# Royal College Street northern extension – audit CCC 27/6/2016

The inspection was carried out by John Chamberlain, James Brander and Jean Dollimore.

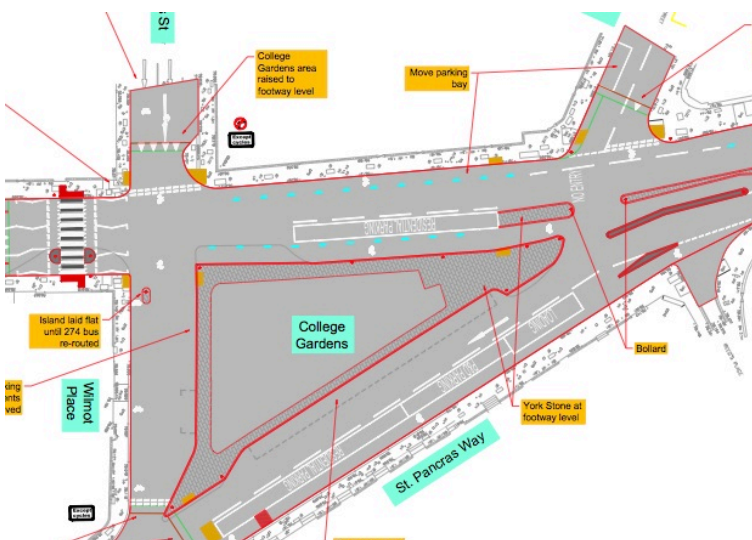
The photo on the left shows the junction of Farrier Street – a good model in that there are clear markings of the cycle track and a logo in front of the exit lane from the side road.

All side road junctions need to have clear line markings and logos. We mentioned the Junction St Pancras Way @ Wilmot Place above. Here are others that require line marking, at least to the edge of the junction.

Ivor Street	Randolph Road	Jeffreys Street

Note also that now that Jeffrey's Street allows contraflow cycling, the No Entry and **also the No right turn** requires an 'Except Cycles' subplate.
